SERVICE BULLETIN

SUBJECT: Recommended Replacement of AEL12892 Thrust Buttons
PURPOSE: To notify customers of a potential incorrect material
COMPLIANCE: At next oil change for parts installed on an engine. For spares, prior to installation

Figure 1.

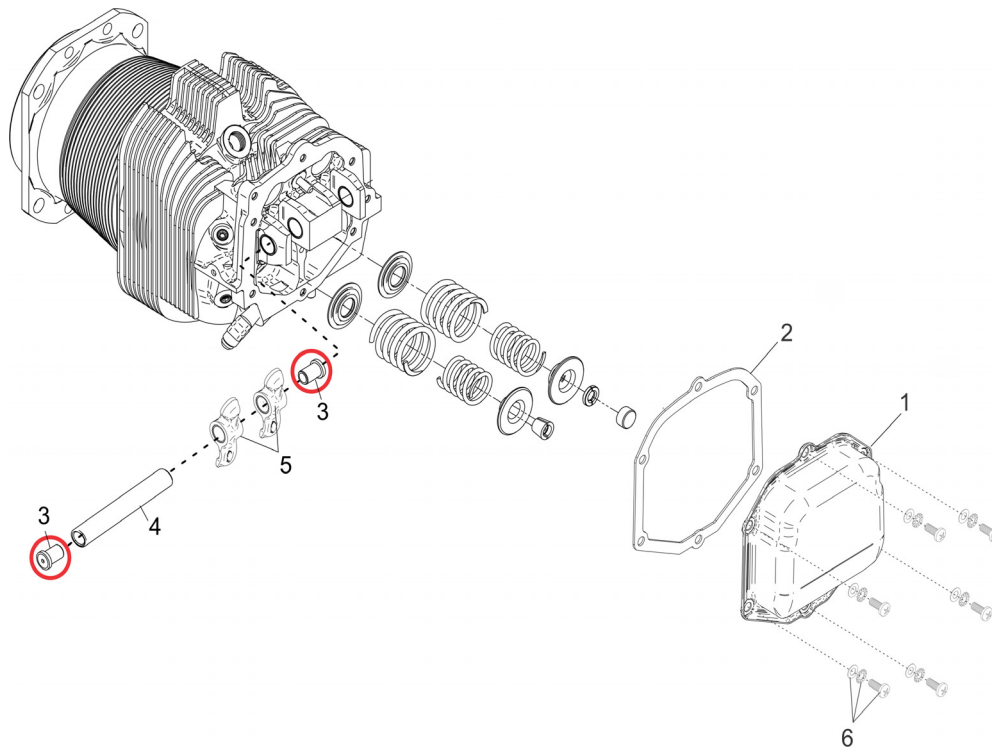
1. Disconnect power to engine.
2. Make sure engine is cool.
3. Remove the rocker cover (Figure 1) (1) and gasket (2) from the cylinder assembly. Discard the gasket (2).

If signs of overheating or accelerated wear of the thrust button (3) are found, ensure that no debris is present in the cylinder drain back line, oil sump, or in the rocker box area and contact Continental. If none are found, proceed to step 4.

4. Remove the thrust buttons (3). Removal of the shaft (4) and rockers (5) is not required.
5. Replace both thrust buttons (3) regardless of condition.
6. Install the rocker cover (1) with a new gasket (2) on the cylinder assembly.
7. Install and torque hardware (6) to the value specified in the engine's primary Instructions for Continued Airworthiness (ICA).
8. Enable power to the engine.
9. Complete the "Operational Ground Check" per the engine's primary ICA.
10. Make an appropriate engine logbook entry to document compliance with SB017.

Figure 2.

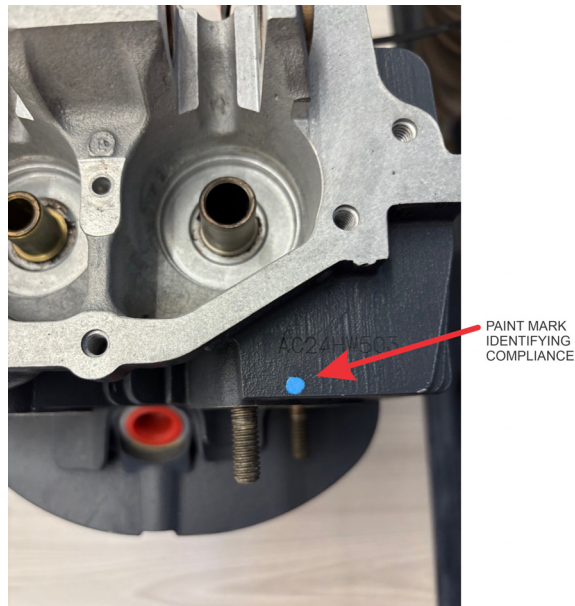
Continental has verified the material on some cylinders at our distributor's facility. The paint mark shown in Figure 2 identifies compliance. If this mark is on the cylinder, no further action is required.
